2 SPAN (99'-7 1/8", 99'-7 1/8") TWIN BRIDGES  
PREFABRICATED CONTECH BRIDGES WITH STEEL WIDE FLANGE GIRDERS  
MEGA TOP DRIVE SOUTH OVER NORTH BEAVER CREEK  
24'-0" ROADWAY CURB TO CURB  
45°00'00" SKEW  
5'-6" SIDEWALK, THRIE BEAM RAIL WITH SAFETY RAIL ABOVE SIDEWALK  
6" CURB, THRIE BEAM

**AS-BUILT/  
CONSTRUCTED**

PROJECT TITLE: FOREST LAKES BRIDGES  
PROJECT LOCATION: MONUMENT, CO  
STRUCTURE: GENERAL INFORMATION  
SHEET NO.: B01

**FOUNDATION LAYOUT**

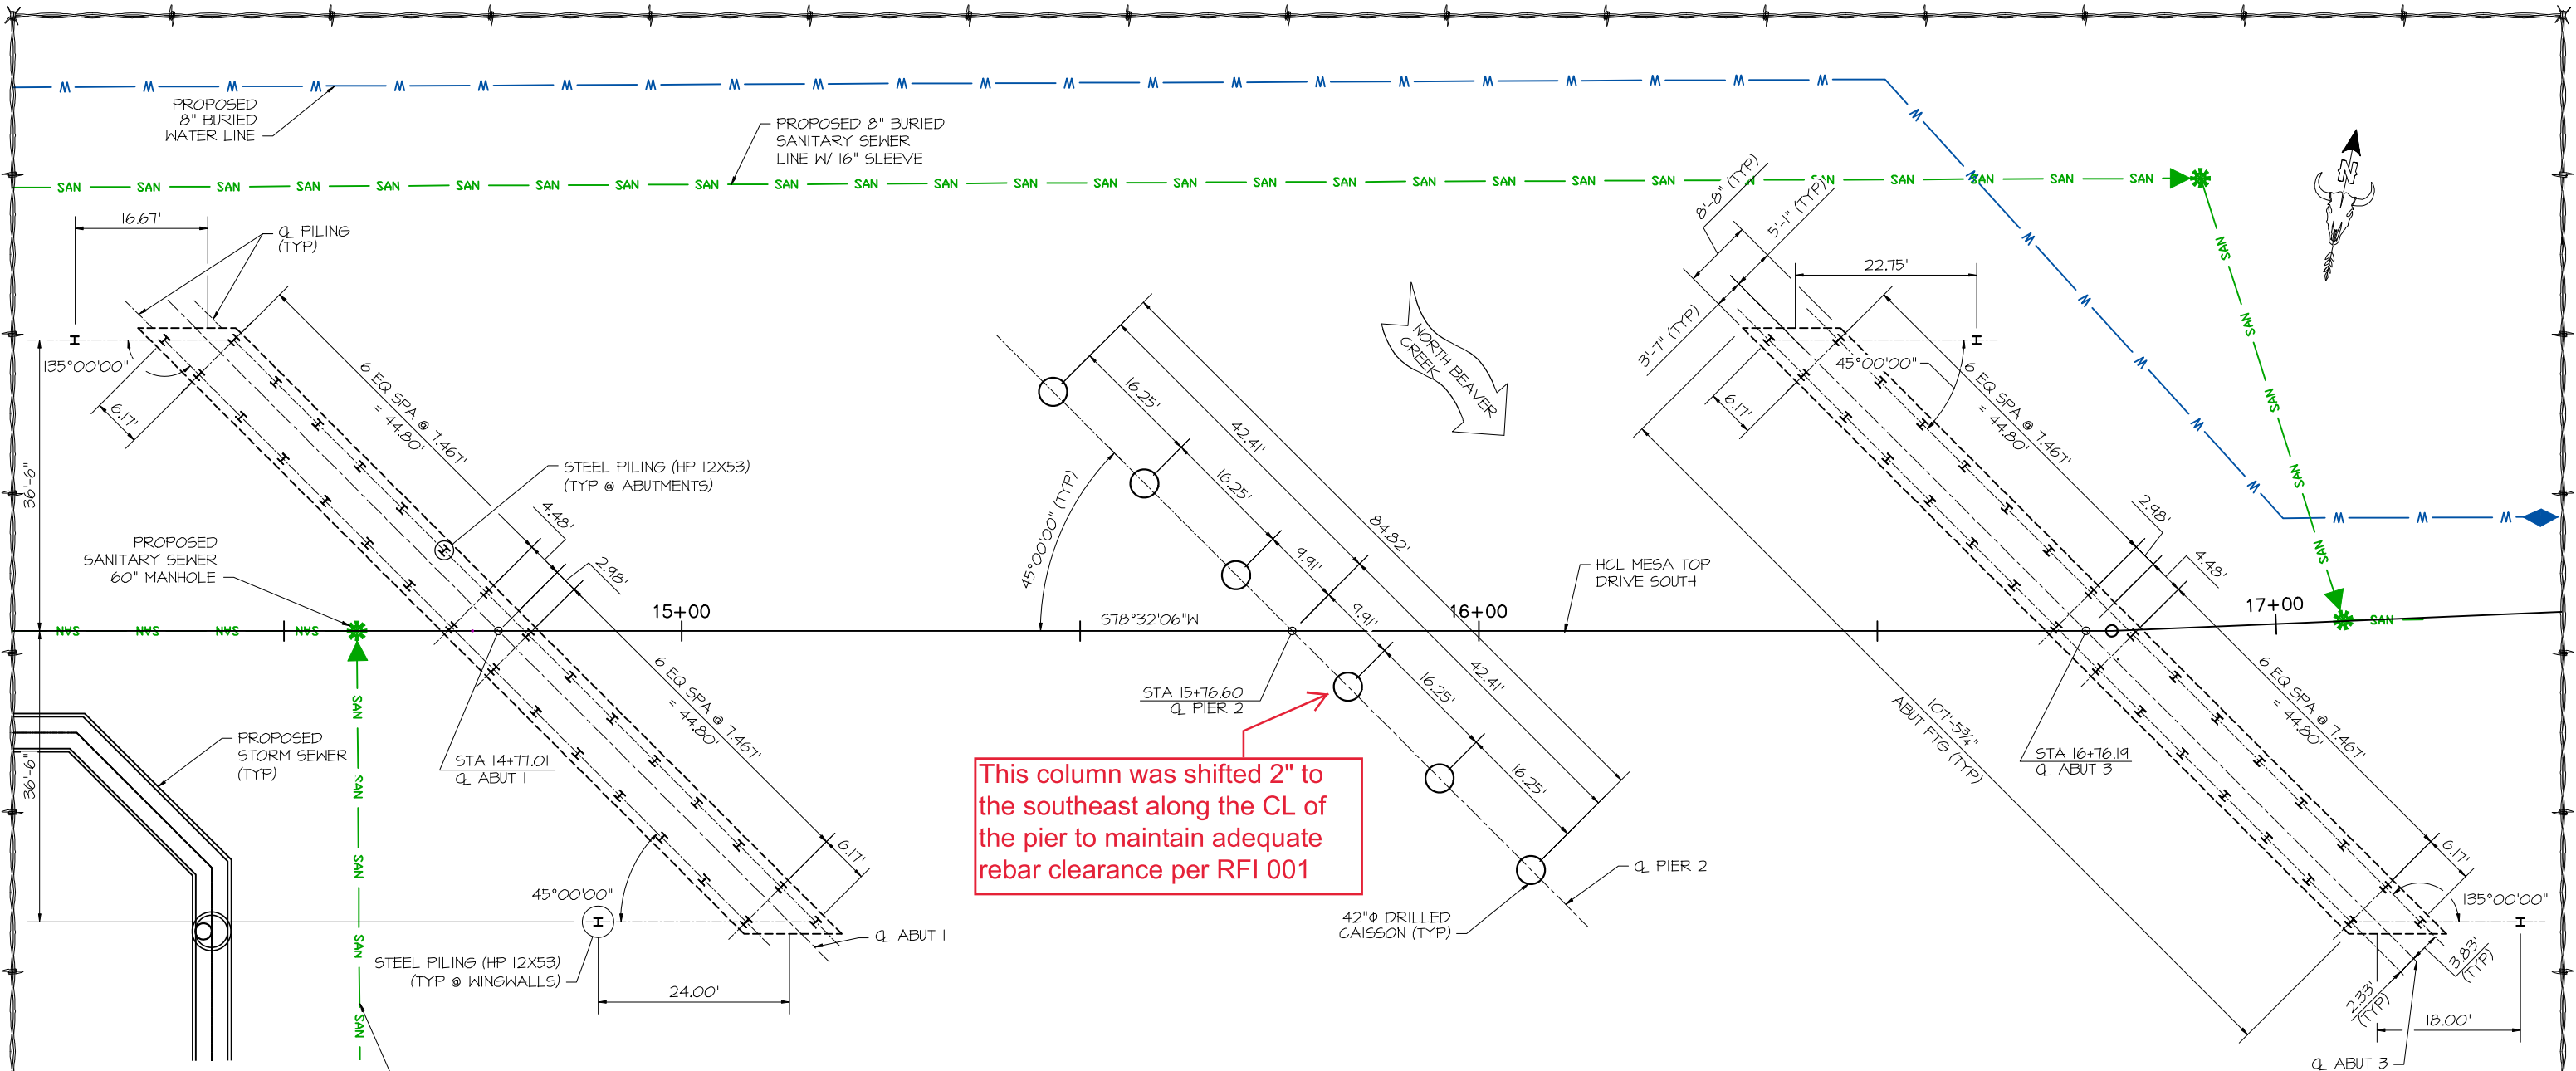
This column was shifted 2" to the southeast along the CL of the pier to maintain adequate rebar clearance per RFI 001

Per the pile driller, piles were embedded +/- 3' into bedrock. Piles were driven until the N count = 120 blows.

PLAN

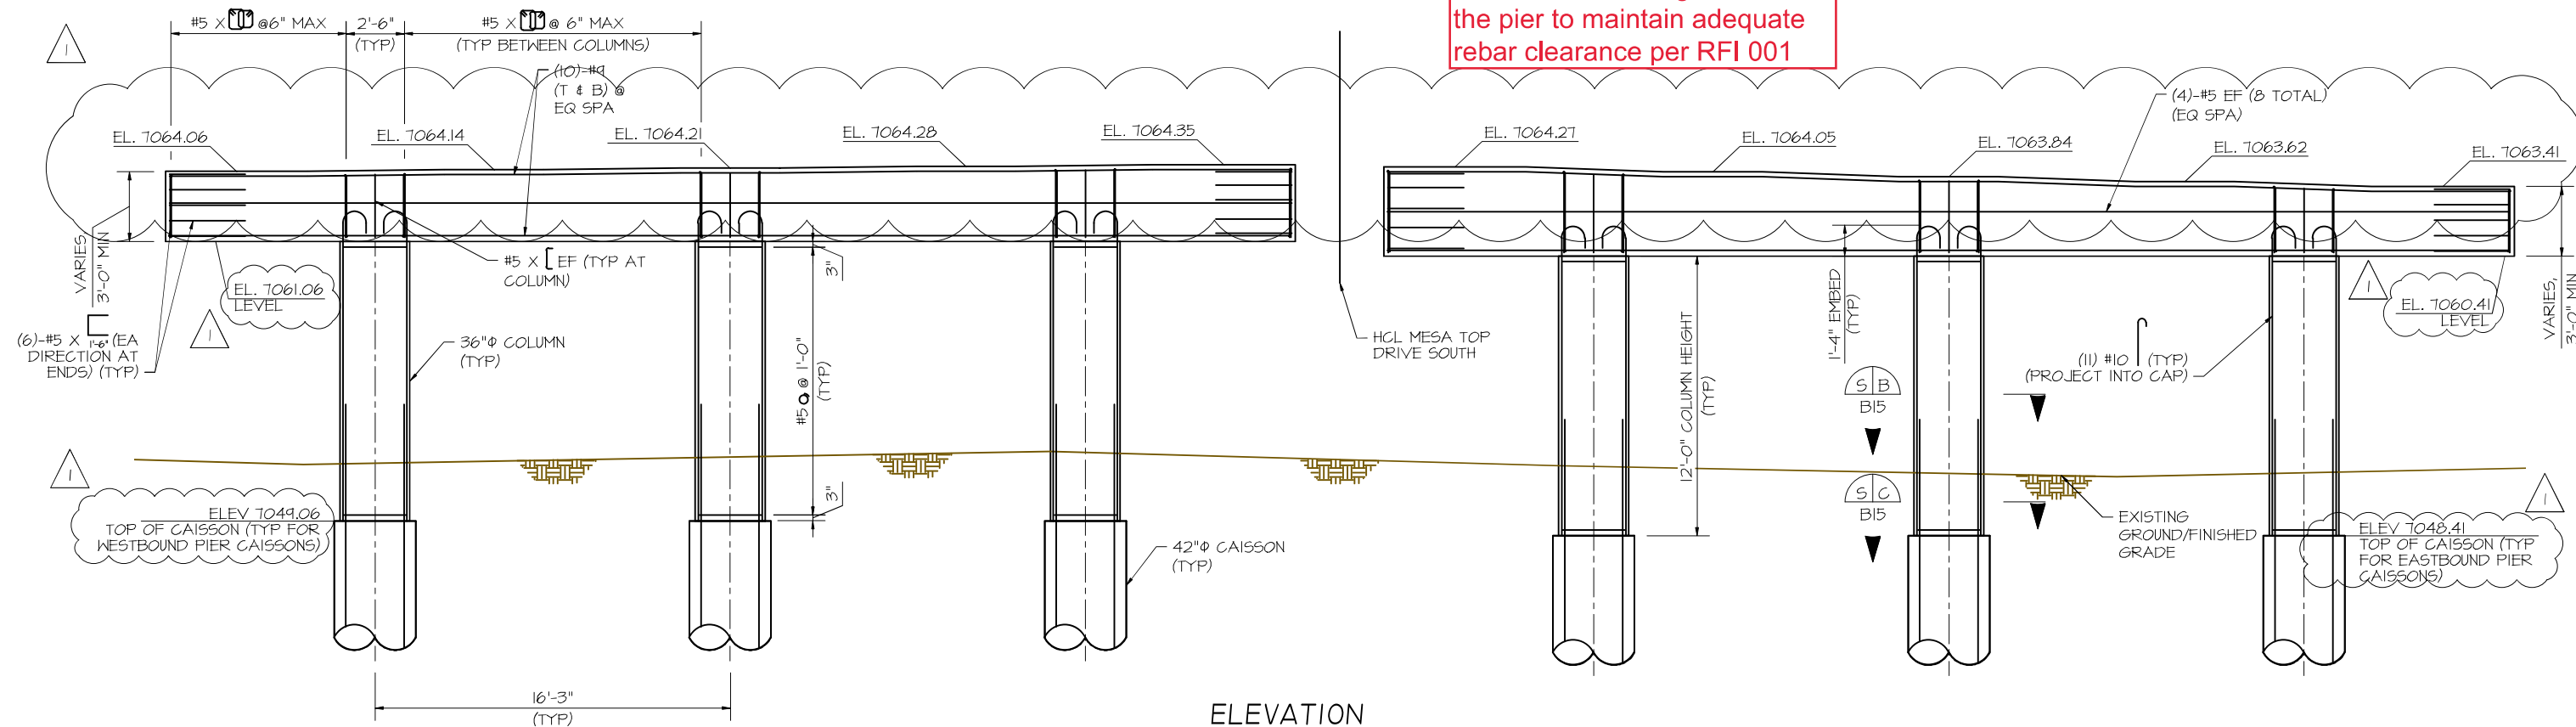
This column was shifted 2" to the southeast along the CL of the pier to maintain adequate rebar clearance per RFI 001
